Joint Meeting of the RID Committee of Experts and the  
Working Party on the Transport of Dangerous Goods

#### Periodic inspection of LPG tank-vehicles

#### Alternatives to the hydraulic test

Transmitted by the European Liquid Petroleum Gases (AEGPL)<sup>1, 2</sup>

Nozzle 1 houses the temperature gauge blind pocket and has a 25 mm long crack as indicated below:

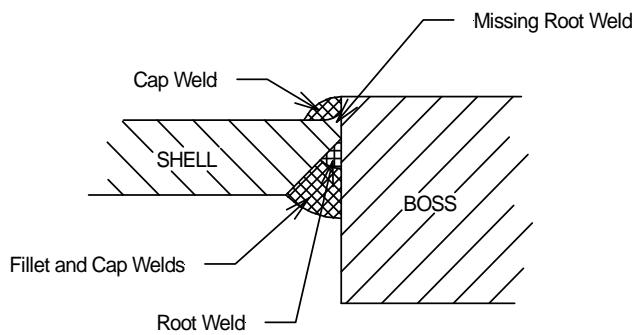
13. As an example a LPG Fixed Tank (manufactured in 1995) recently passed a hydraulic test (in 2011) which was undertaken before any other tests were conducted. The subsequent visual and magnetic particle inspections of some of the nozzle welds found cracks between 25 – 90 mm long in three welds.

Following the initial indications of cracking light grinding of the surface was undertaken to ensure that it was not just weld overlap, however it was confirmed that all three were hairline cracks (the white background paint and black indicator has now made these very visible to the naked eye).
